**International  
Aero Engines**

# SERVICE BULLETIN

Subject: Transmittal of Revision 1 to Service Bulletin Number V2500-ENG-73-0135

## ENGINE - POWERPLANT - REWORK OF THE TERMINAL BLOCK ASSEMBLY

REWORK OF TERMINAL BLOCK ASSY  
FIGURE 1 SHEET 1

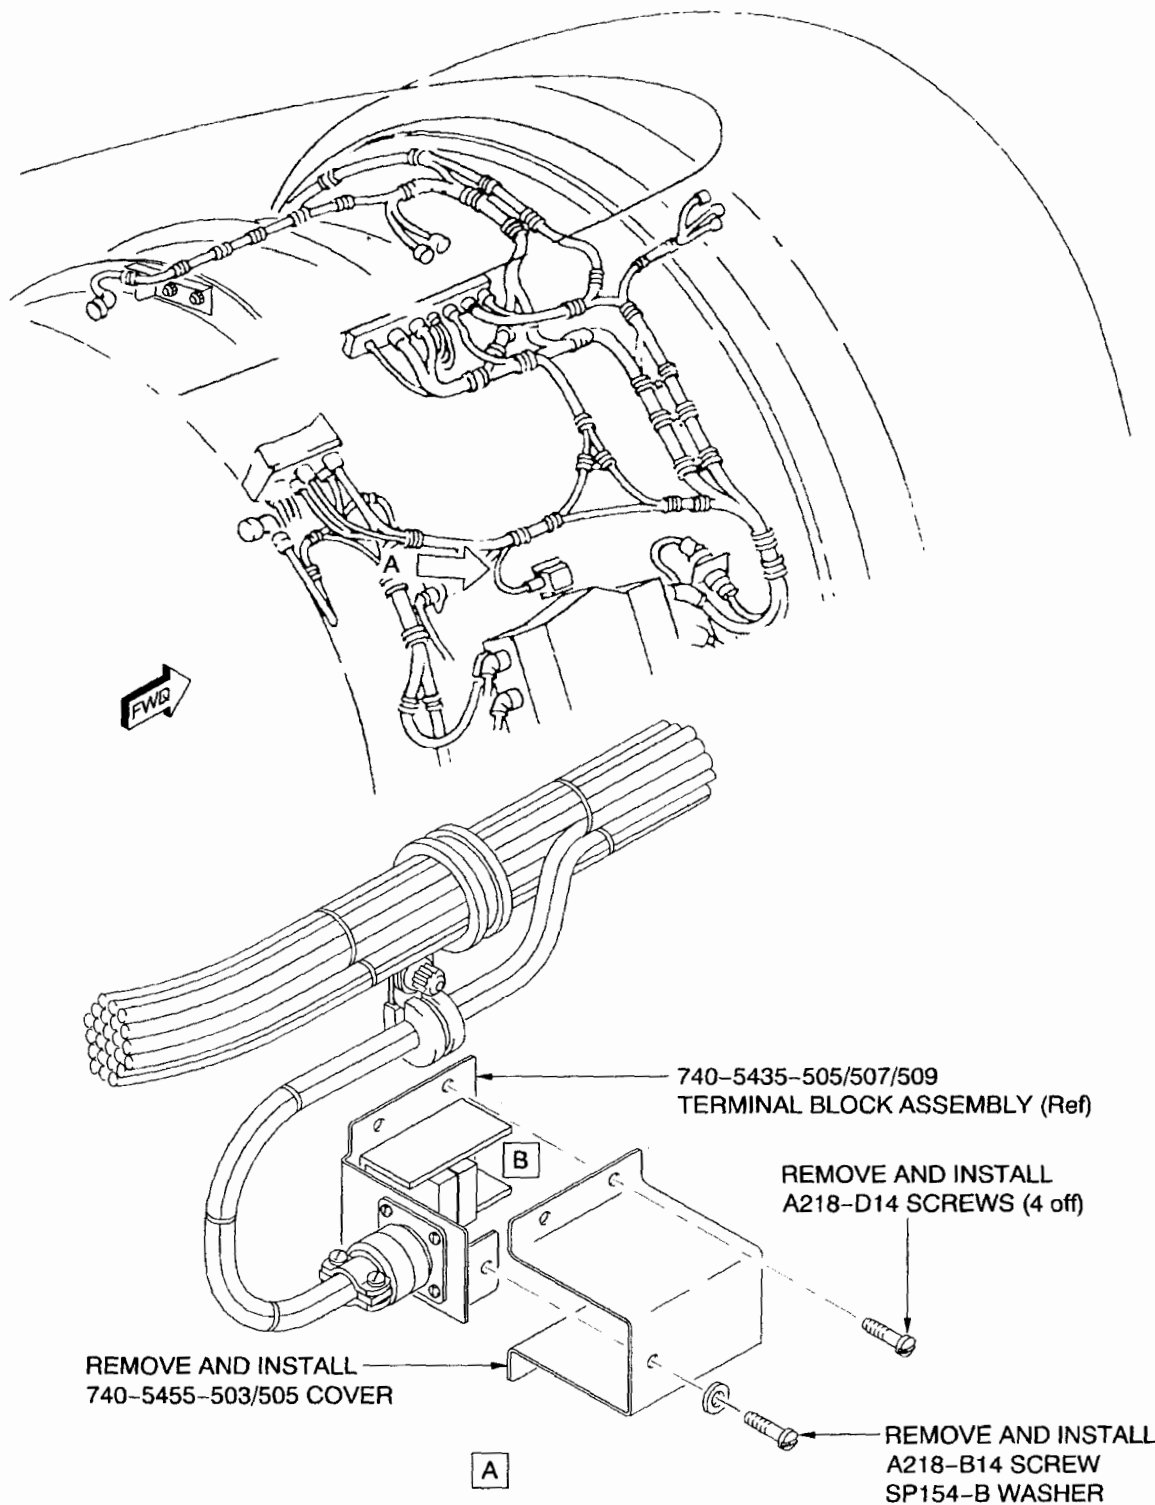
- (1) Remove the four A218-D14 Screws, A218-B14 Screw and SP154-B Washer to release the 740-5455-503/505 Cover from the 740-5435-505/507/509 Terminal Block Assembly. Remove the cover. Refer to Figure 1, sheet 1.
- (2) Loosen the 592144-1 Self Locking Screw to enable free movement of the End Block Assembly. Refer to Figure 1, sheet 2.
- (3) Remove the two A218-B14/A206-B14 Screws to release the MRTB-2 Terminal Block Mounting Rail. Let the Mounting Rail remain in position.
- (4) Move the End Block Assembly along the Mounting Rail to the End Stops.
- (5) Move the M81714/3-B-B1 and M81714/3-B-A1 Terminal Blocks along the Terminal Block Mounting Rail towards the End Stops.

- (14) Make sure that the Terminal Blocks are secure and do not move in their positions.
- (15) Install the 740-5455-503/505 Cover to the 740-5435-505/507/509 Terminal Block Assembly with the four A218-D14 Screws and A218-B14 Screw and SP154-B Washer. Refer to Figure 1, sheet 1. Torque the five Screws to 40 lbfin (4.5 Nm).

REWORK OF TERMINAL BLOCK ASSY  
FIGURE 1 SHEET 3

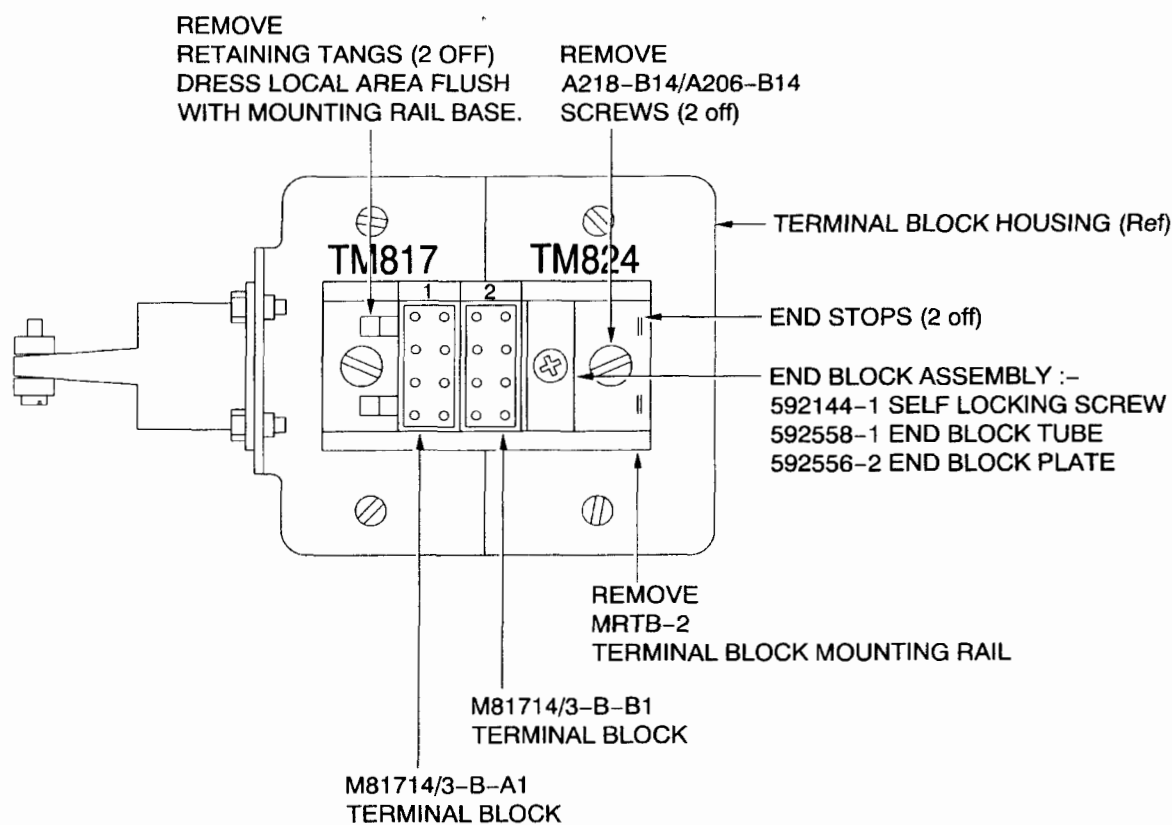
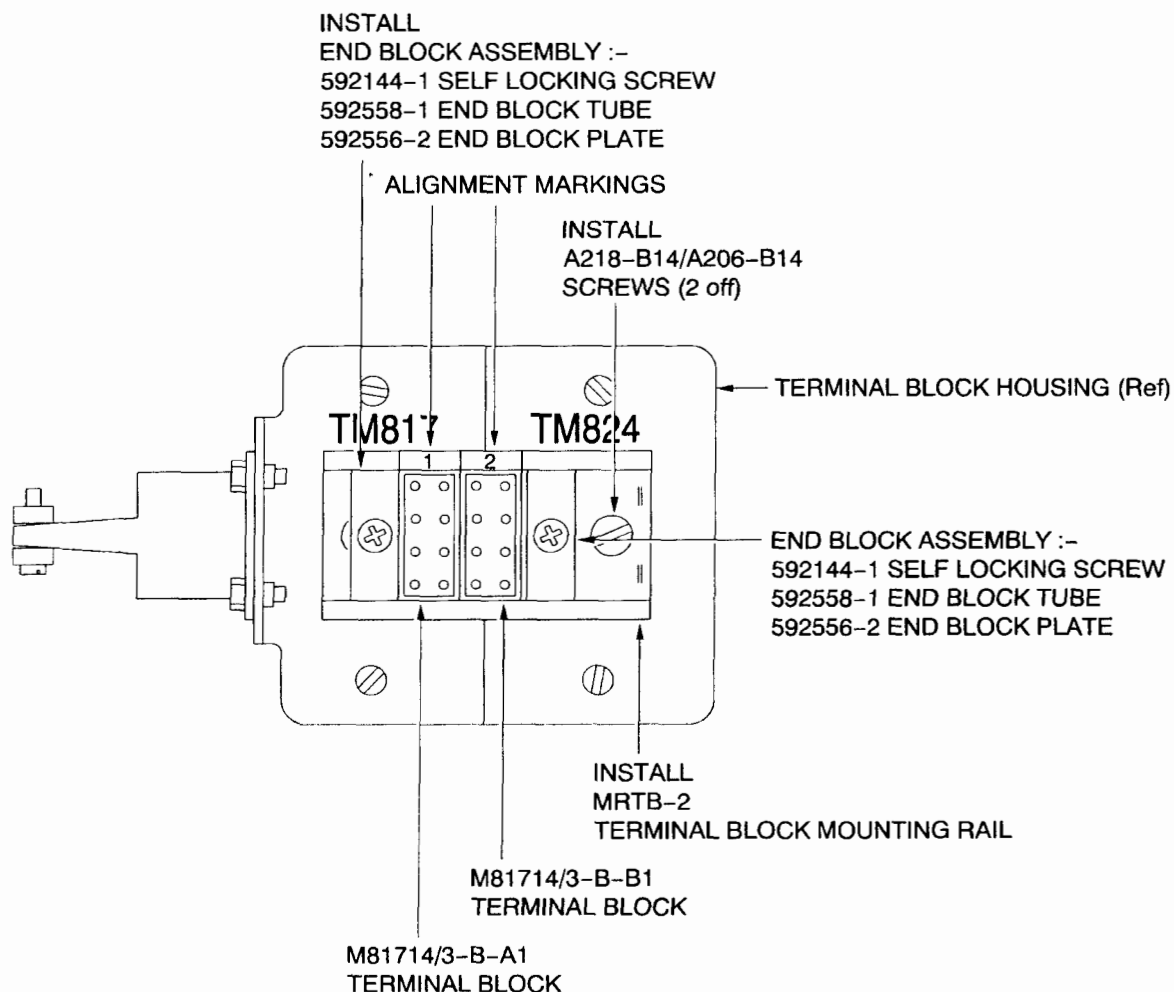
- (a) The cover of the Terminal Block Assembly is removed. The Mounting Rail is disconnected and the Terminal Blocks moved to obtain access to the Retaining Tangs. The Retaining Tangs are removed and the local area dressed flush. A new End Block Assembly is installed and the Terminal Blocks are placed back in position and fixed in location with the End Blocks. The cover of the Terminal Block Assembly is re-installed.

- (6) Carefully remove the Mounting Rail from the Terminal Block Housing.
- (7) Carefully break off the Mounting Rail Tangs from the Mounting Rail and make the remaining stems of the Tangs level with the Mounting Rail Base. Remove all sharp edges.

- (9) Install the new End Block Assembly to the Mounting Rail as shown in Figure 1, sheet 3. Let the 592144-1 Self Locking Screw remain loose to enable free movement.
